Proposal for the 01 series of amendment to UN Regulation No. 136 (Electric vehicle L)

Submitted by the Working Party on Passive Safety *

The text reproduced below was adopted by the Working Party on Passive Safety Provisions (GRSP) at its seventieth session (ECE/TRANS/WP.29/GRSP/70, para. 24). It is based on ECE/TRANS/WP.29/GRSP/2021/22 as amended by Annex VII to the report. It is submitted to the World Forum for Harmonization of Vehicle Regulations (WP.29) and to the Administrative Committee (AC.1) for consideration at their June 2022 sessions.

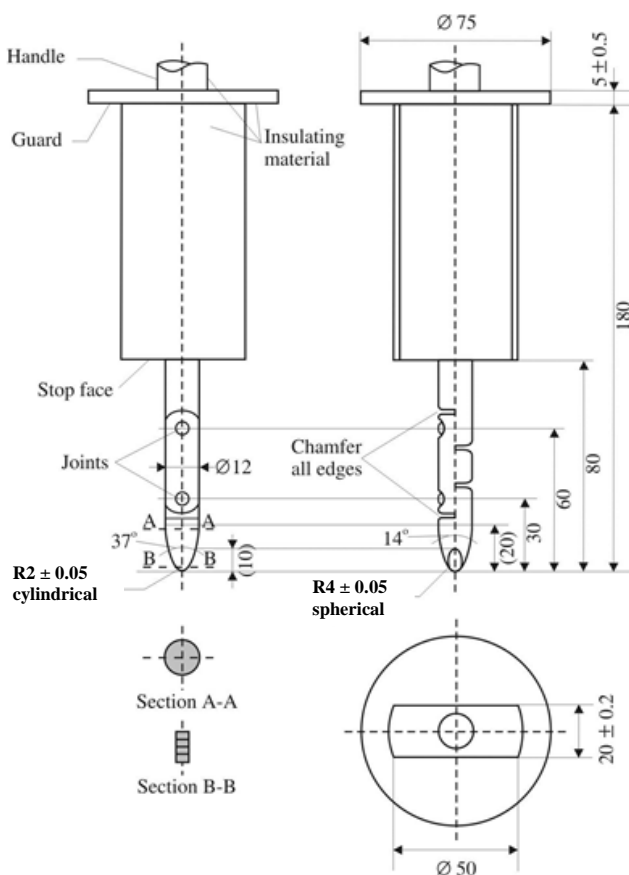
In the case of the test for protection degree IPXXB, the jointed ...

In case of the tests for protection degree IPXXD, the access probe ..."

Annex 3, Figure 1, shall be deleted.

Annex 3, insert new Figure 1 to read:

Figure 1

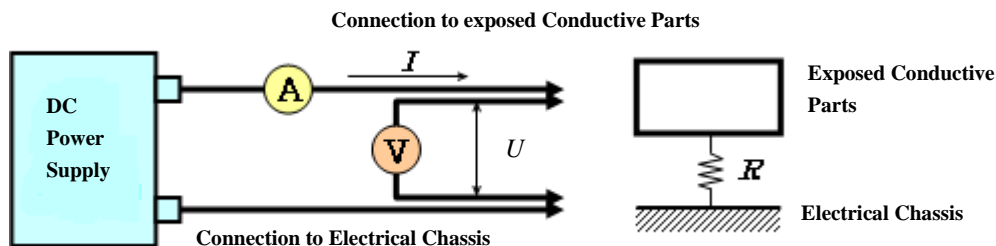
Throughout Annex 5A (new), including figures, replace the symbols for voltage, V, V_b, V₁, V₁', V₂, V₂', with U, U_b, U₁, U₁', U₂, U₂'.

Figure 1
Standard Nozzle for the Test

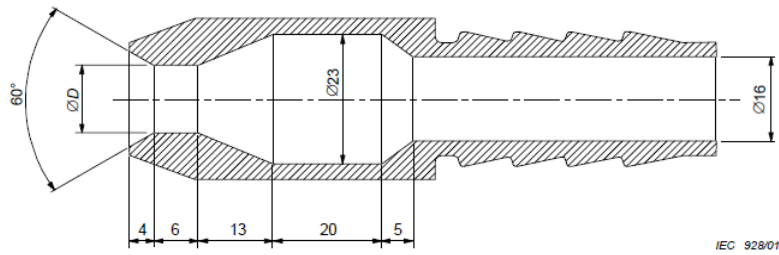
- 2.2. For electrical components, externally attached (e.g. in engine compartment), open underneath, both exposed or protected locations, the testing authority shall verify, with a view to confirming the compliance, whether the test is conducted by spraying the high-voltage component or system from all practicable directions with a stream of water from a standard test nozzle as shown in Figure 1. The following parameters are observed during the test in particular:

- (a) Nozzle internal diameter: 6.3 mm;
 - (b) Delivery rate: 11.9 – 13.2 l/min;
 - (c) Water pressure at the nozzle: approximately 30 kPa (0.3 bar);
 - (d) Test duration per m² of surface area of the tested high-voltage component or system: 1 min;

- (e) Minimum test duration: 3 min;
 - (f) Distance from nozzle to tested high-voltage component or system surface: approximately 3 m (this distance may be reduced, if necessary to ensure proper wetting when spraying upwards).

Figure 2
Splashing Test Nozzle

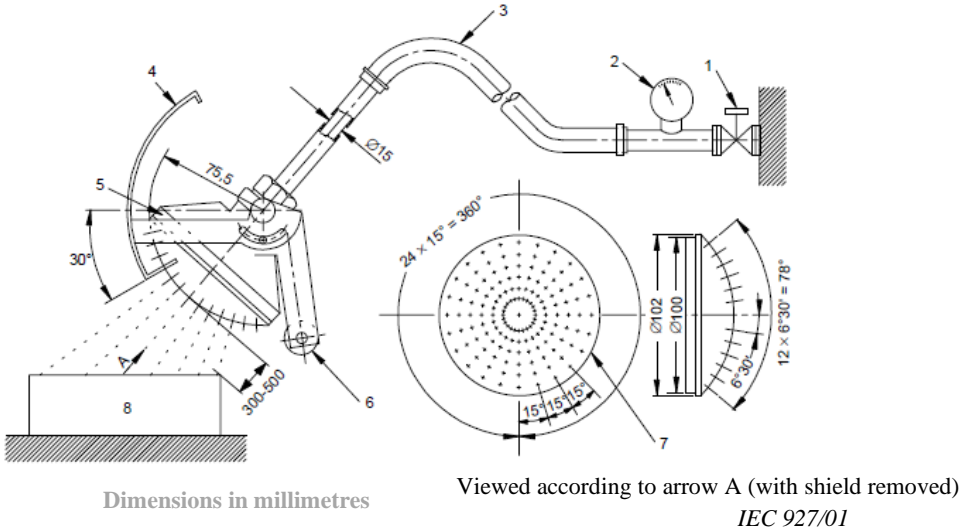
- 2.3. For externally attached electrical components (e.g. in the engine compartment), covered from underneath, the testing authority shall verify the compliance, whether:
- The cover protects the component against direct spray water from underneath and is not visible;
 - The test is conducted by using the splashing test nozzle as shown in Figure 2;
 - The moving shield is removed from the spray nozzle and the machine is sprayed from all practicable directions;
 - The water pressure is adjusted to a delivery rate of (10 ± 0.5) l/min (pressure approximately 80 kPa to 100 kPa (0.8 bar to 1.0 bar));
 - The test duration is 1 min/m² of calculated surface area of the machine (excluding any mounting surface and cooling fin) with a minimum duration of 5 min.
